630.11166 RU4 Rezoning 20151103.doc

Oakdale South Estate Review of Proposed RU4 Rezoning of Adjacent Site

SLR Consulting Australia Pty Ltd (SLR) has been engaged by Goodman Property Services (Aust) Pty Limited (Goodman) to conduct a review of the proposed RU4 – Primary Production Small Lots rezoning of the rural site adjacent to Goodman's Oakdale South Estate (OSE).

Figure 3 Areas of Compliance with $L_{Aeq}(15 \text{ minute})$ Night Criterion (Light Green)

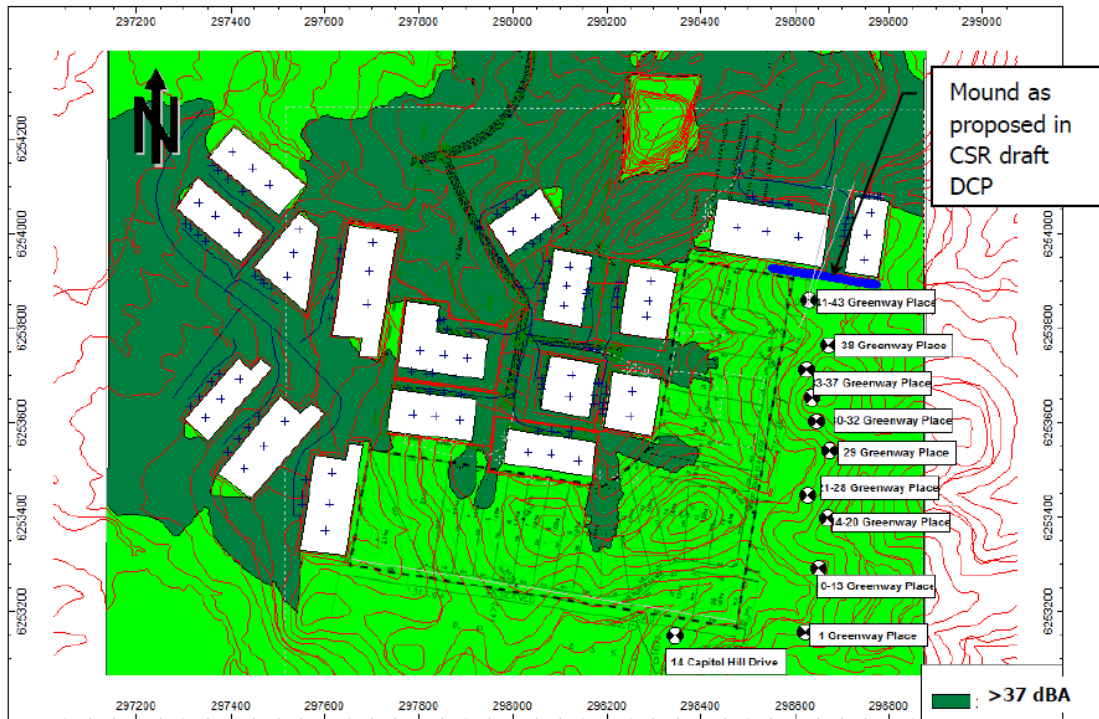
It should be noted that the 10196-R assessment uses an indicative layout for the noise modelling of the OSE.

Figure 1 Oakdale South Estate Operations 37 dBA LAeq(15minute) Noise Contour

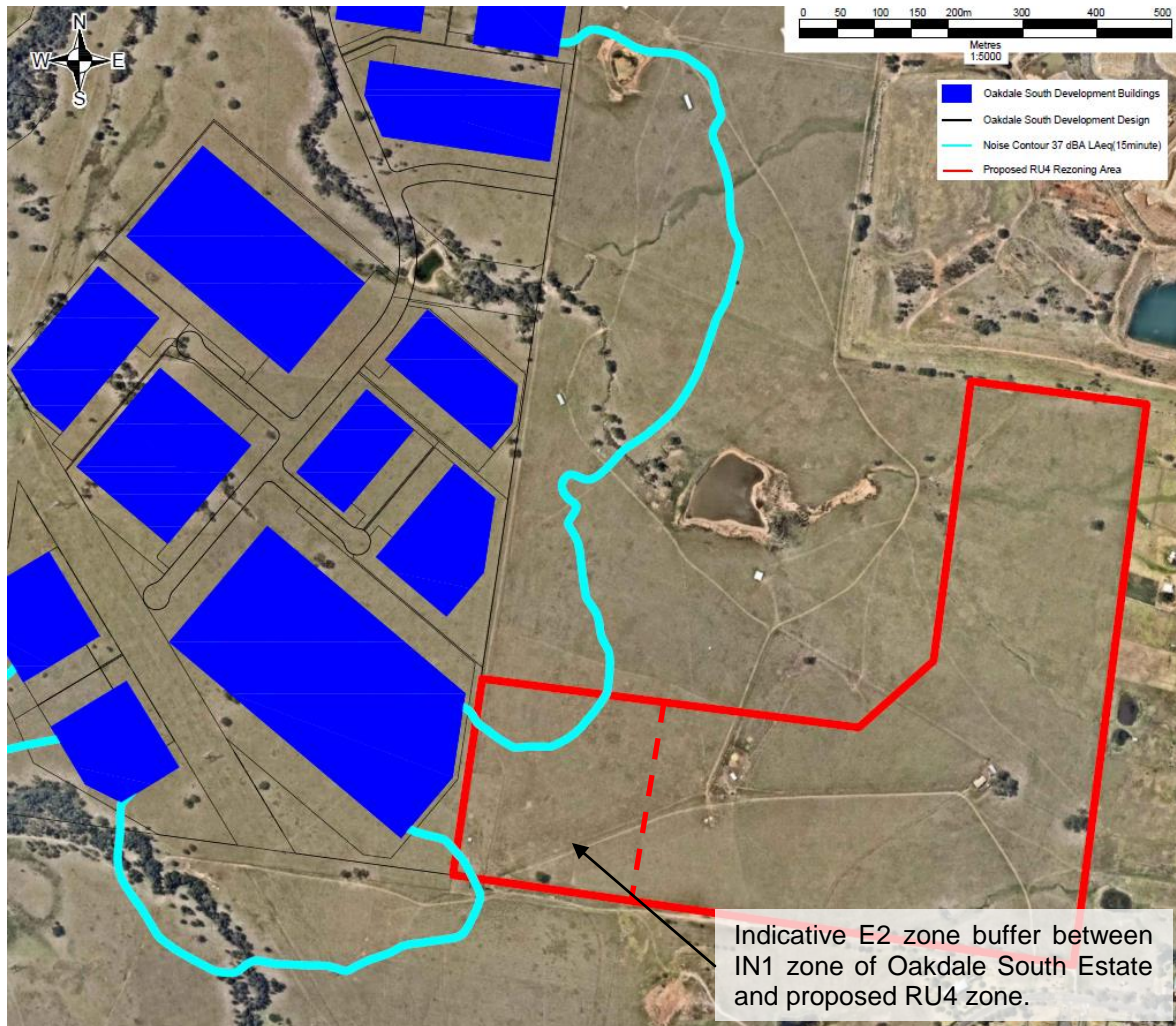
Figure 1 shows that two areas in the west of the proposed RU4 rezoning area lie within the 37 dBA LAeq(15minute) noise contour. These areas are approximately 165 m by 100 m and 35 m by 35 m in size.

It is our recommendation that an E2 zone buffer be set aside around these areas (at a minimum) as a buffer zone between the IN1 zone of the OSE and the proposed RU4 zone. An indicative E2 zone buffer is shown in **Figure 1**. Residential uses would not be suitable within this buffer zone. Outside of the buffer zone noise mitigation would not be required at residential receivers with regards to noise emissions from the OSE.

If no buffer zone is implemented, or if residences are proposed to be developed within the buffer zone then noise mitigation should be incorporated into the design of the residential developments on the proposed RU4 site. Indicative noise mitigation measures that could be implemented on the RU4 site include noise mounds or barriers close to the RU4 site boundary or at residential buildings, or architectural treatments designed into the residential buildings.
